Subject: **ADDENDUM NO. 2**

Project: **A NEW SECURITY & SERVICES TRAINING FACILITY**

Job #: **ANG# BRKR009063 / SSL# 12072**

The plans and Specifications for the New Security & Services Training Facility, dated March 2022 are amended as follows. (Where there are conflicts between the plans and specifications and the addendum, this addendum shall govern).

6 L1.1 Landscape Section (Base Bid)
1" = 1'-0"

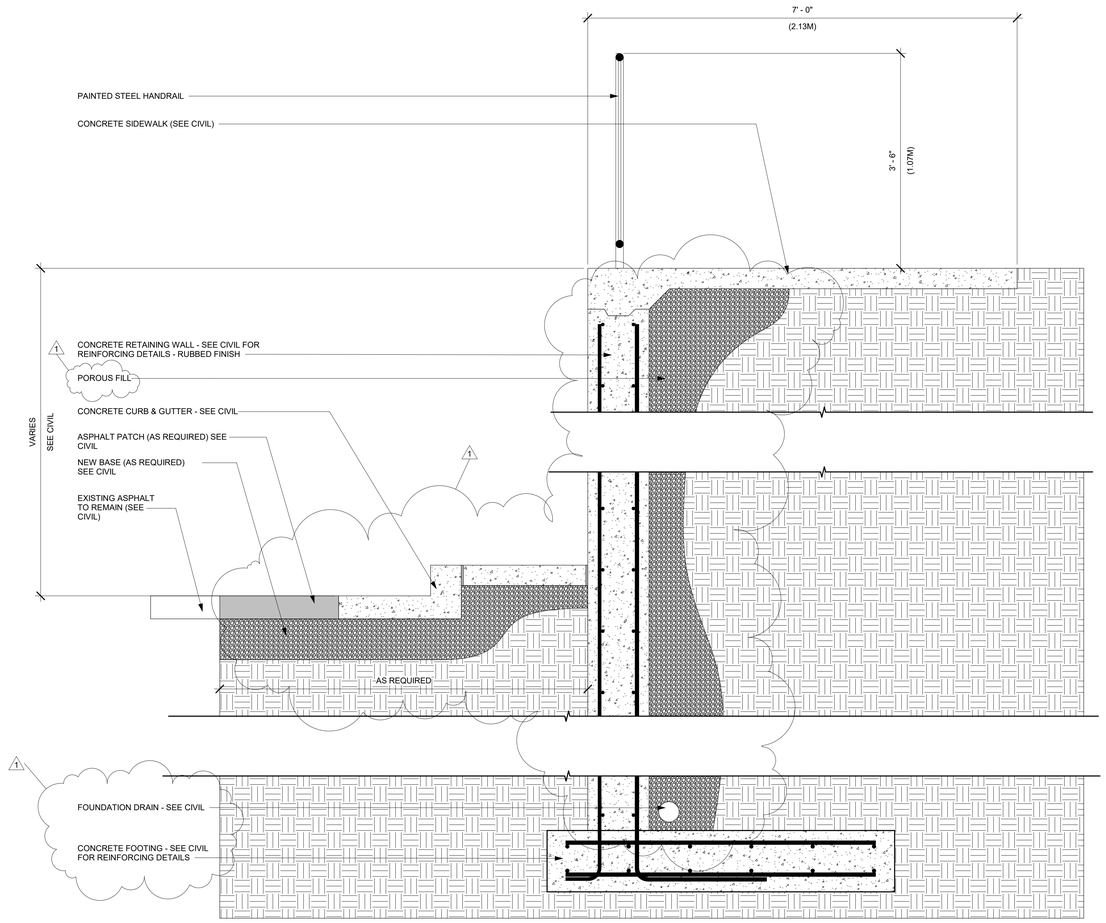
a. Installation of a CMU wall with brick cladding and cast stone coping on all sides of the mechanical courtyard as indicated on drawings 1 and 2 on sheet L1.1. Refer to landscaping and civil drawings for height of wall.

b. Installation of chain link fencing covering the top of mechanical courtyard as indicated on drawings 1 and 2 on sheet L1.1.

c. Installation of decorative metal gate as indicated on drawings 2, 3, and 4 on sheet L1.1.

2. If this bid option is not awarded, the base bid shall consist of the lower height CMU/Brick veneer retaining wall with painted steel guardrail depicted on drawing 5/L1.1. Gate depcited on sheet L1.1 will not be required as part of the base bid.

1 A2.4 Wall Type Plan - Base Bid
3/32" = 1'-0"

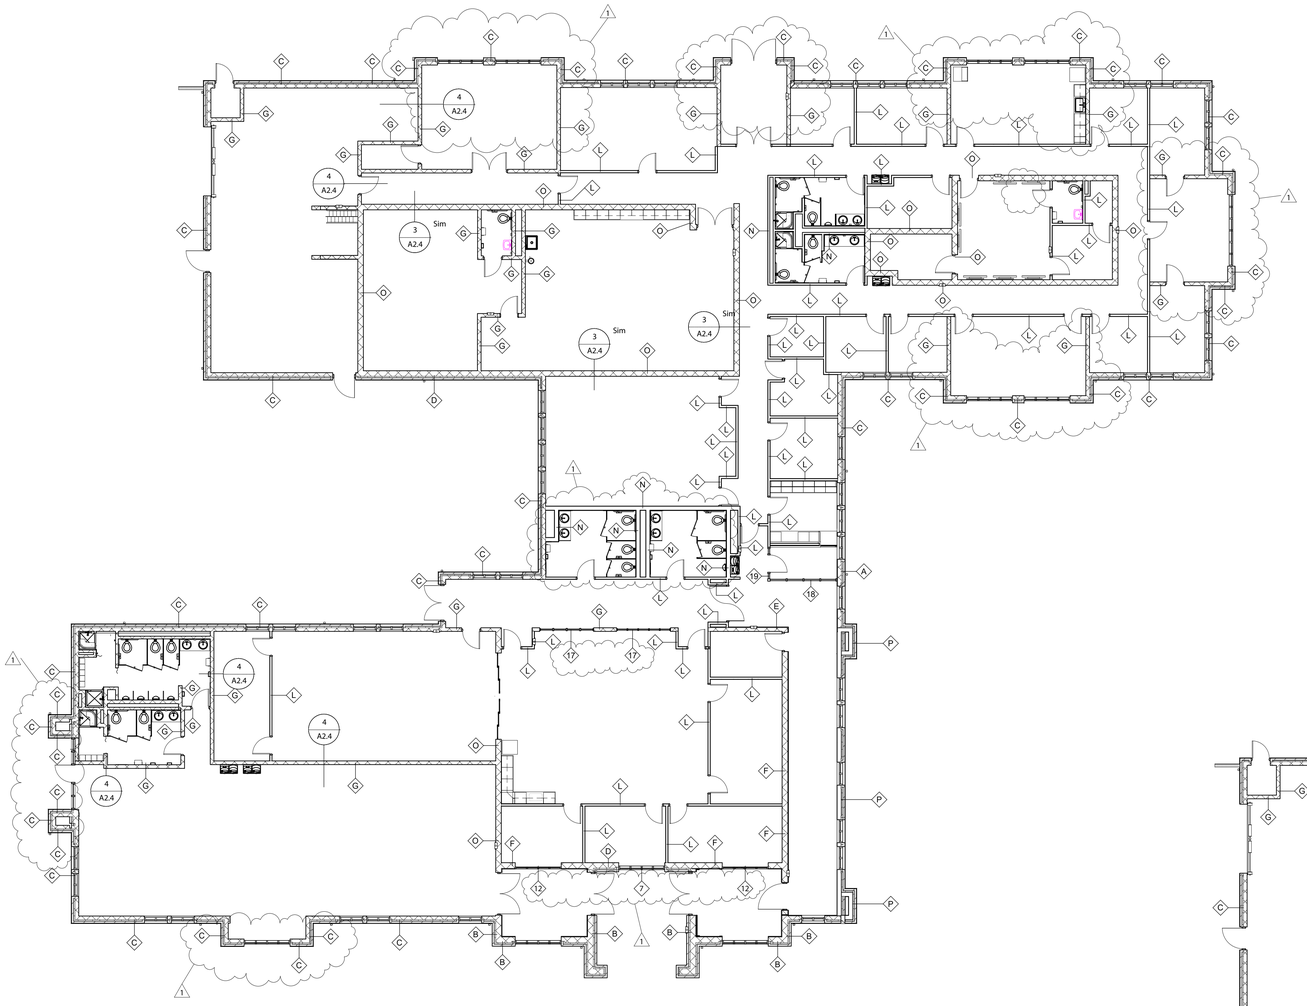
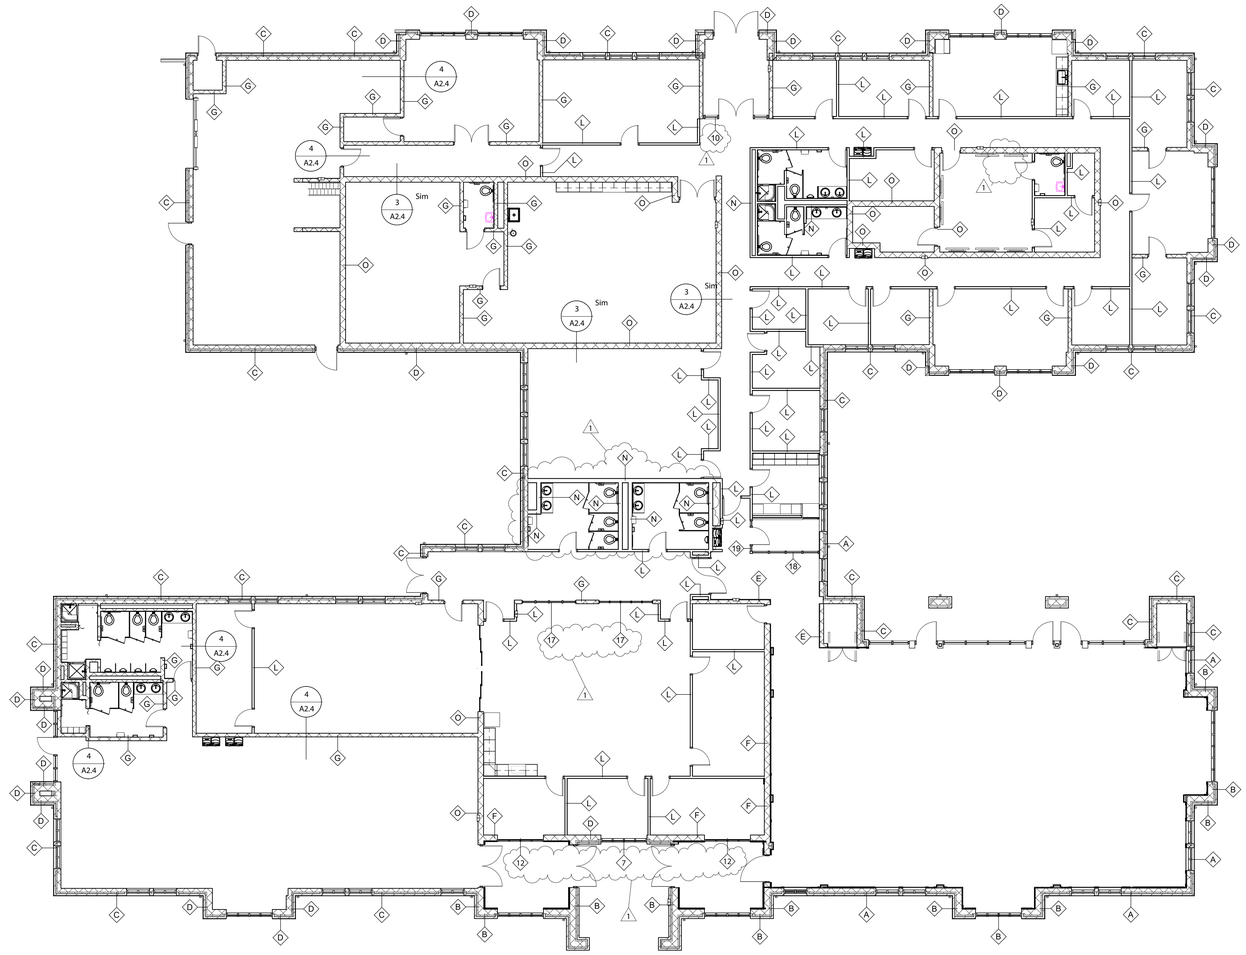
1) The metal furring indicated for wall types A and B on drawing 2 & 5 on sheet A2.4 is not included in this bid option. If this option is awarded, the load bearing CMU walls will be exposed in these rooms. Painting of exposed CMU surfaces in these rooms is also not required as part of this bid option.

a. Installation of metal stud furring and gypsum wall assemblies at wall type A and B indicated on drawing 2/A2.4 within rooms 108, 108b, 109a, 109b, and 109c.

1 A8.1B Reflected Ceiling Plan (Bid Option)
1/8" = 1'-0"

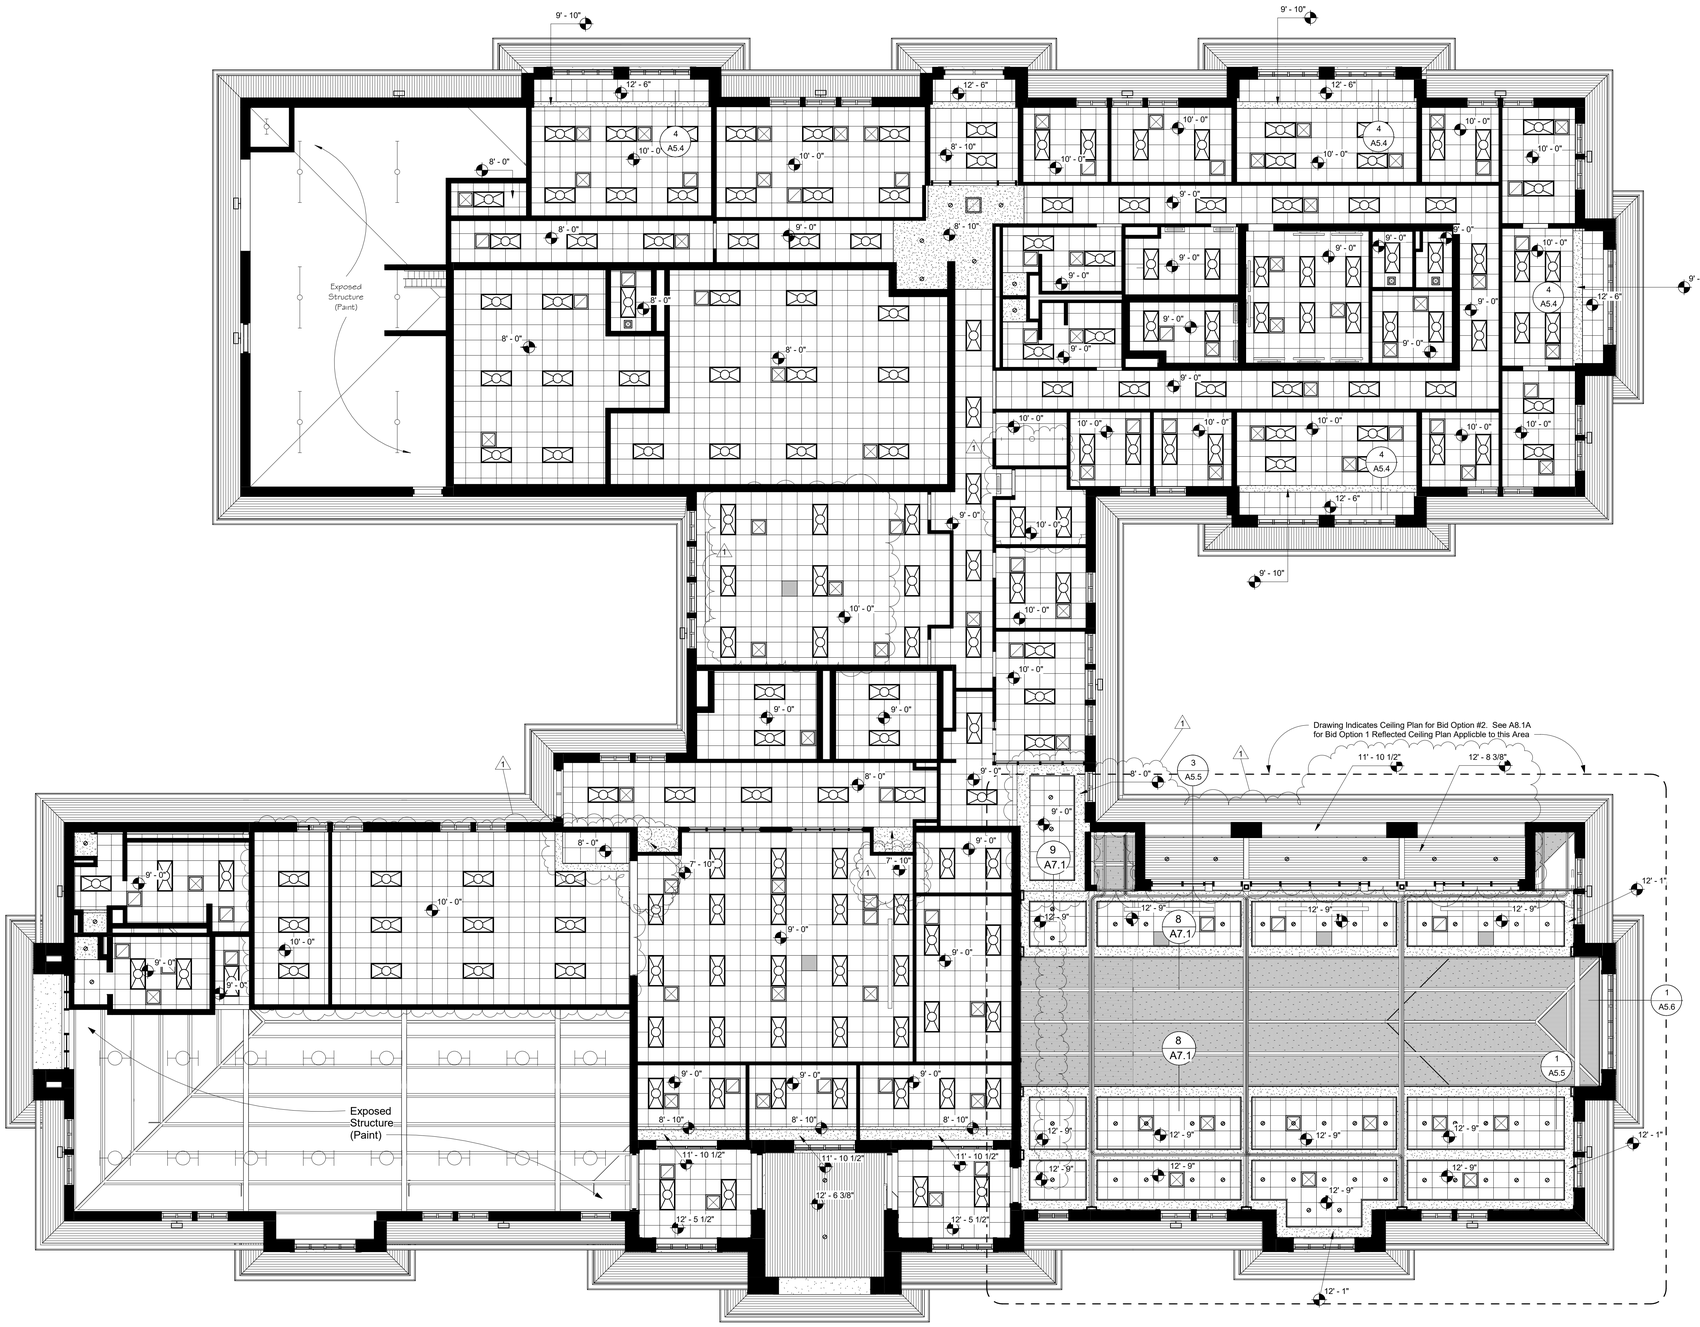
b. Installation of acoustical tile ceiling assemblies, metal stud framing/gypsum board ceiling treatment, and decorative wood ceiling panels and trim indicated on drawing sheet A8.1B.
